**ROTHER LOCAL PLAN
2025-2042 –
DEVELOPMENT
STRATEGY AND SITE
ALLOCATIONS
CONSULTATION
RESPONSE
GROVE FARM, PHASE 2**

ACCESS REVIEW TECHNICAL NOTE

APPENDIX 4
HIGHWAYS PRE-APP RESPONSE

Location: Land at Grove Farm (Phase 2)
George Hill
Robertsbridge
TN32 5BY

Figure 3.1 – Option 1 access – south of Heathfield Gardens

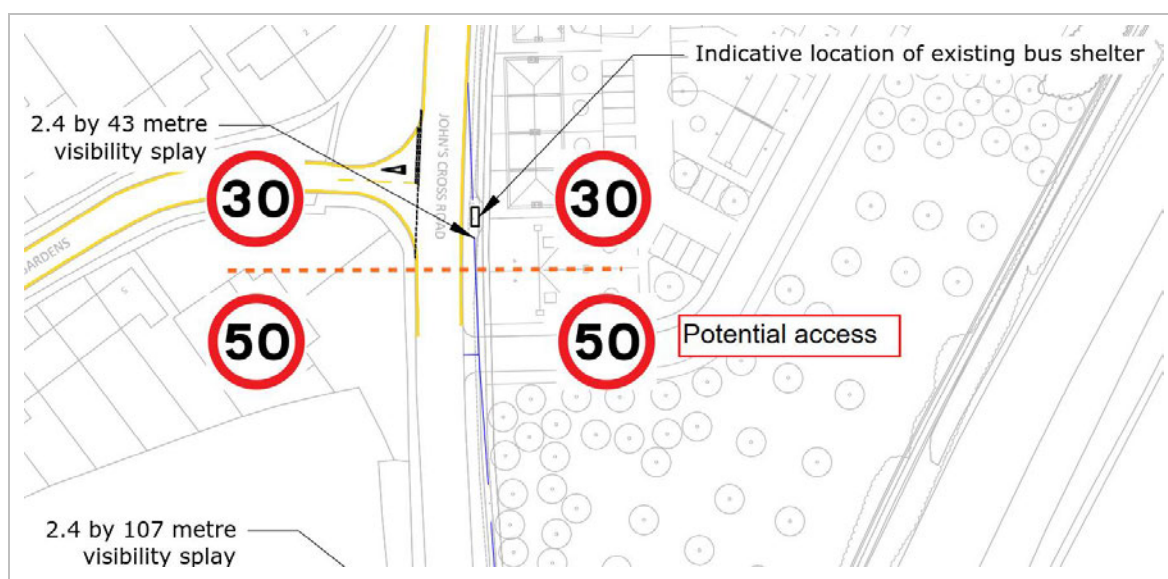
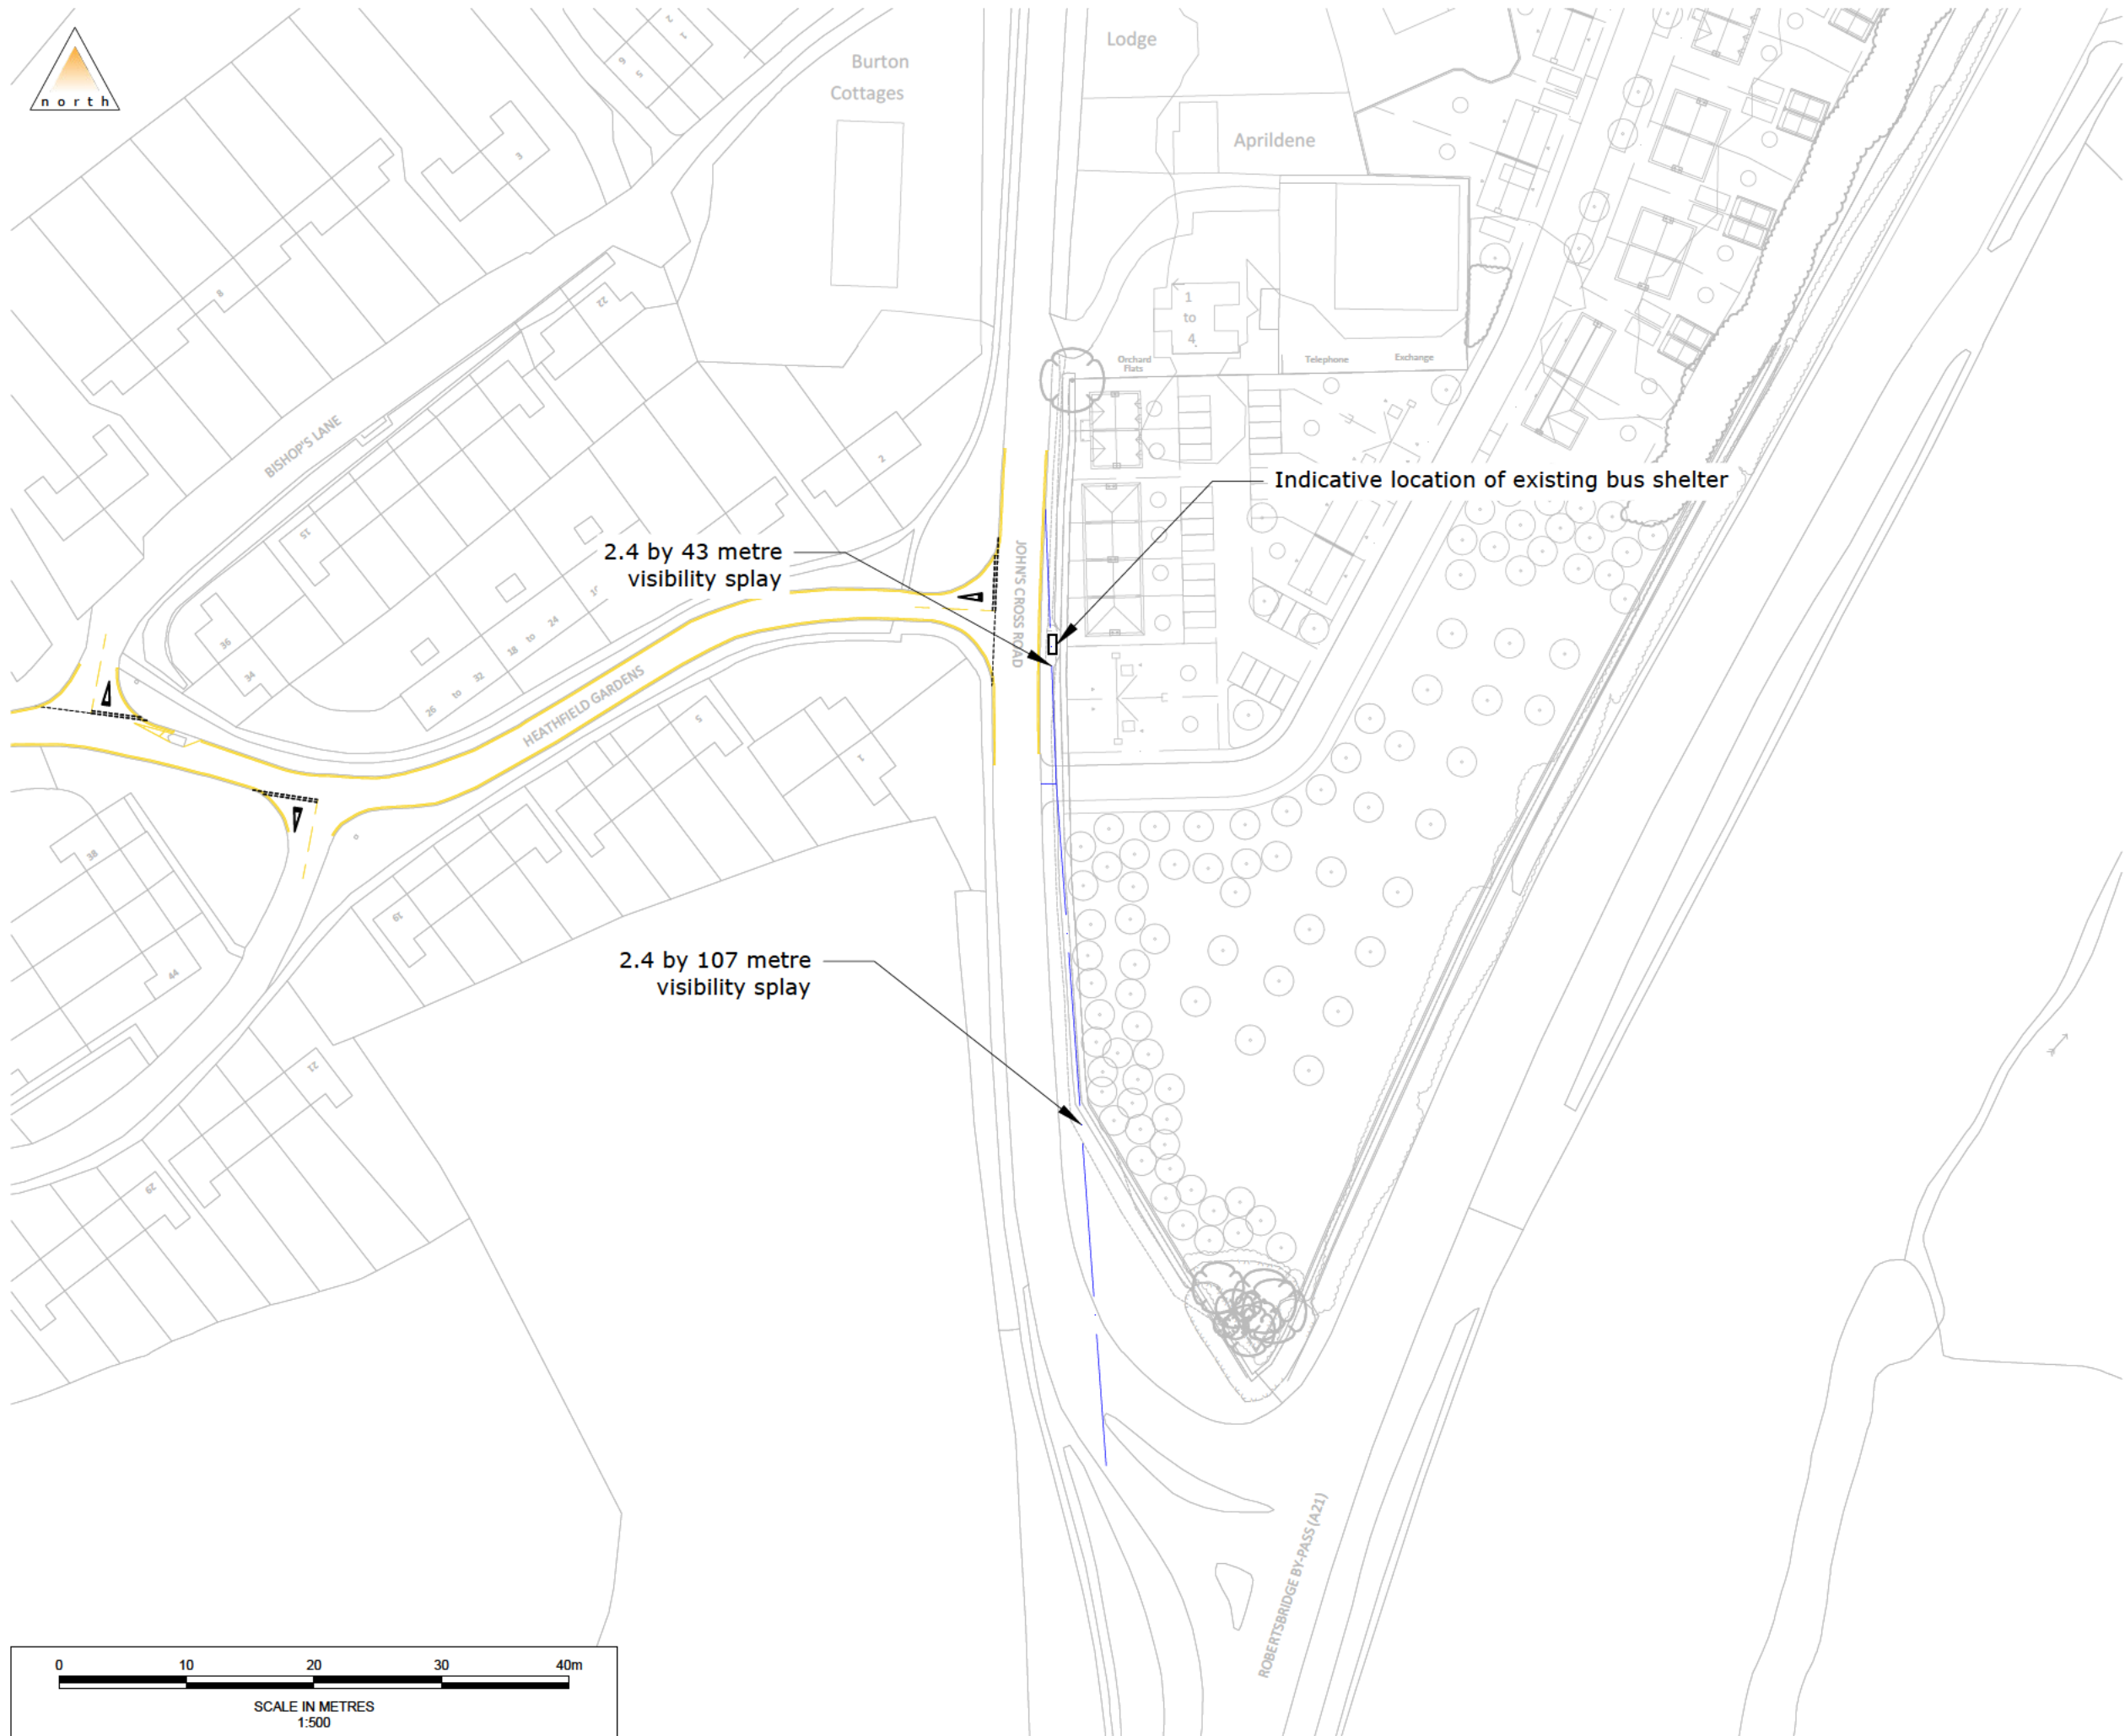
- 3.12 The Option 1 access location has been reviewed in terms of the likely acceptability of the arrangement. The comments are as follows;
- ▶ The driver visibility splay to the north (2.4m x 43m) can be achieved on the basis that the southbound vehicles are approaching at speeds in the order of 30mph.

- ▶ The existing hedgerows will need to be trimmed back and maintained on a regular basis;
 - ▶ The splay to the north may need to increase if recorded traffic speeds are more than 30mph, drivers leaving the village may accelerate as they approach the 50mph limit. There is some flexibility to increase the splay if required but any restriction will be the hedgerow to the east of George Hill along the site frontage;

- ▶ The existing bus shelter to the north of the junction appears to block the splay to the north but this is effectively a single screen parallel to George Hill without any sides to obstruct driver visibility.

- ▶ The driver splay to the south of the Option 1 access (2.4m x 107m) will not meet the required 2.4m x 160m necessary for a 50mph but this could not be achieved in any event since the location of the Option 1 junction is only 150m from the George Hill/A21 Robertsbridge By-pass. The existing hedgerows will need to be trimmed back and maintained on a regular basis as with the visibility to the north; and

- ▶ It will be necessary to discuss and agree with ESCC and National Highways a departure from standard for the splay to the south. The results from the Automatic Traffic Count may provide information to suggest traffic is travelling slower which could justify a reduced driver visibility splay – traffic would need to be recorded travelling at speeds in the order of 40mph – 43mph.

Regarding option 1, the splay to the south is considered achievable. However, the splay to the north goes directly through the bus stop. As discussed in more detail later in this report, this bus stop is used as a 'timing point'. As a result, buses may wait at these stops for extended periods if they arrive early which would obstruct the visibility splay.

Heathfield Gardens, the proposed site access, and the access associated with the live application at the time of writing (reference RR/2025/1438) to the south could result in conflict due to their relatively close spacing. When considered alongside the position of the bus stop, the Highway Authority has concerns with access option 1.

- 3.13 The delivery of the Option 1 access from George Hill to serve the Phase 2 site will require existing hedgerows to be trimmed and maintained and the delivery of the southern driver visibility splay will require a departure from standard from the local highway authorities unless a reduced traffic speed is recorded as part of the site speed survey. Any trimming of the hedgerow would be in accordance with typical landscaping maintenance.
